InfiMedia Inc.

TO: Steve Pullen
FROM: Jim Banner
DATE: 10/1/99

- 8 pages of draft text for comments 22-33
- 2 exhibits
- 6 pages of lithologies
- 10 pages of a Groundwater Monitoring Suspension Request

EXHIBIT No. 2

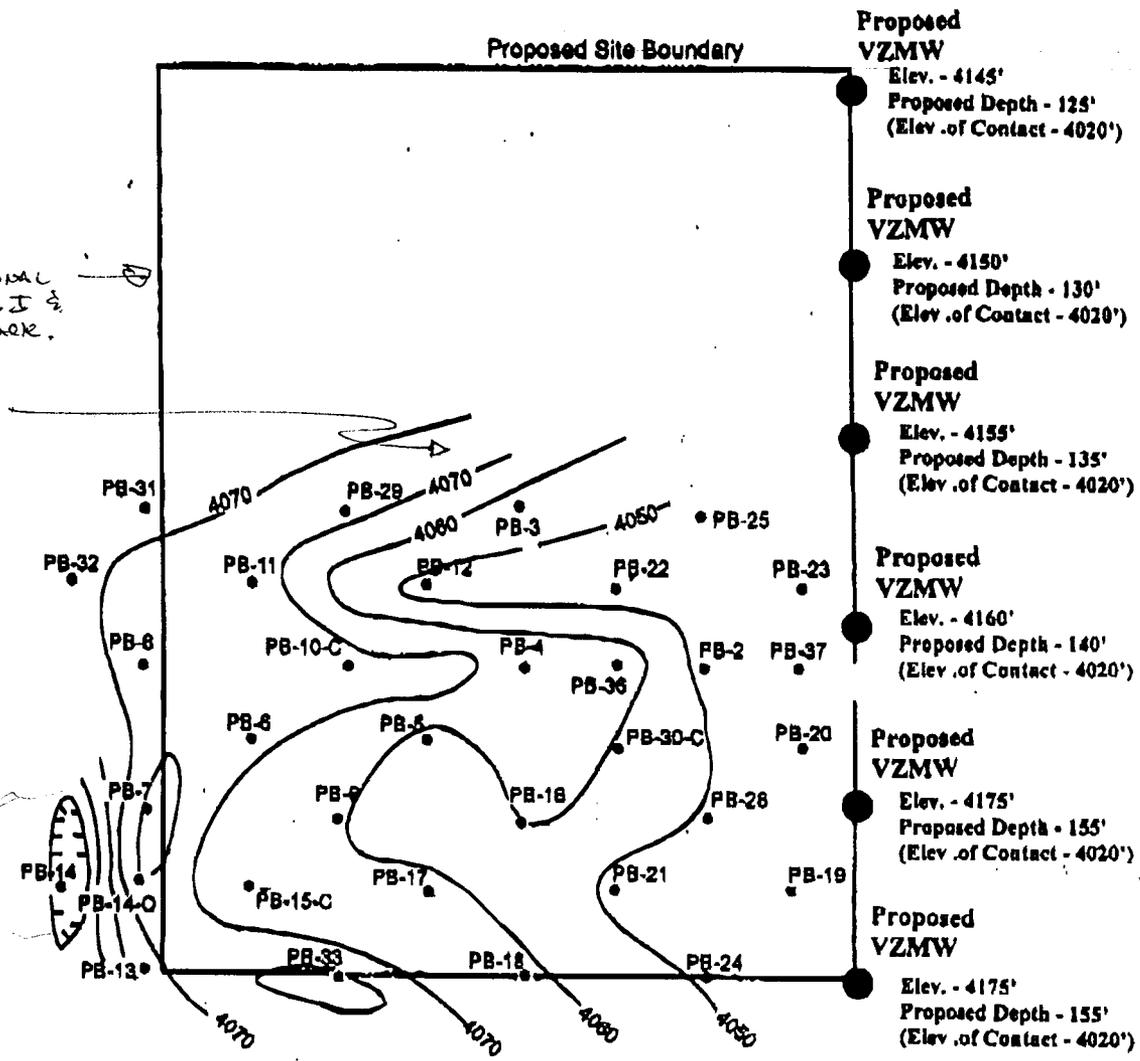
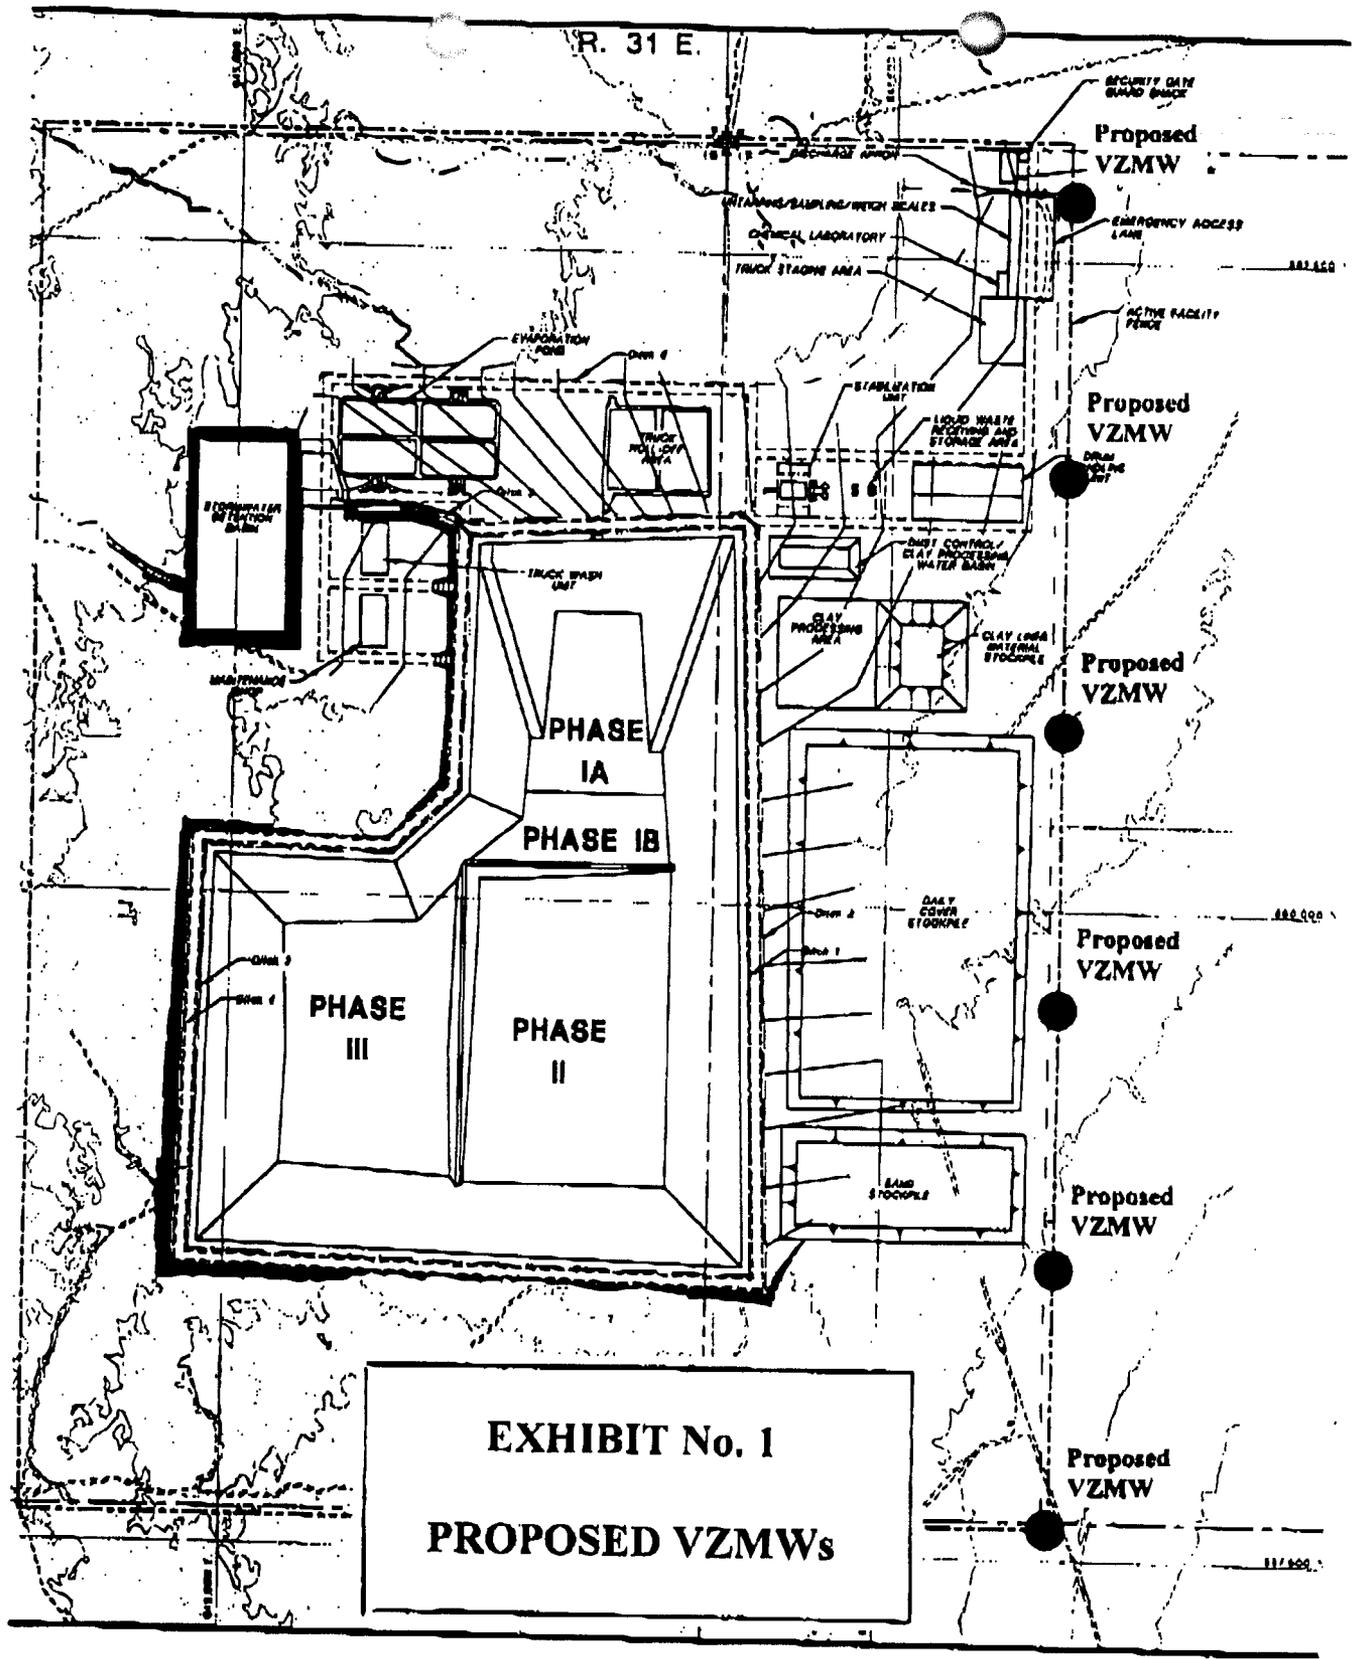
- IS THIS A GOOD IC

- ANY OTHER CONSTRUCTIVE DETAILS?
- LENGTH OF SCREEN?
- SUMP IN BOTTOM

IS THERE A
"RIDGE" TO THE
TOP OF THE LD?

Exhibit No. 2 is a structure contour map of the Upper/Lower Dockum contact as requested in Comment No. 30. The proposed VZMWs are shown along the eastern boundary of the facility. The lowest identified elevation of this contact is 4039 feet and is located in a hydrologic trap west of the site boundary (PIB-14). The lowest identified elevation of this contact east of the site is 4046 feet (PIB-38). It is proposed that all VZMWs be completed to an elevation of a least 4020, which would ensure the contact between the Upper and Lower Dockum had been penetrated. Exhibit No. 2 also shows the depths of these proposed wells.
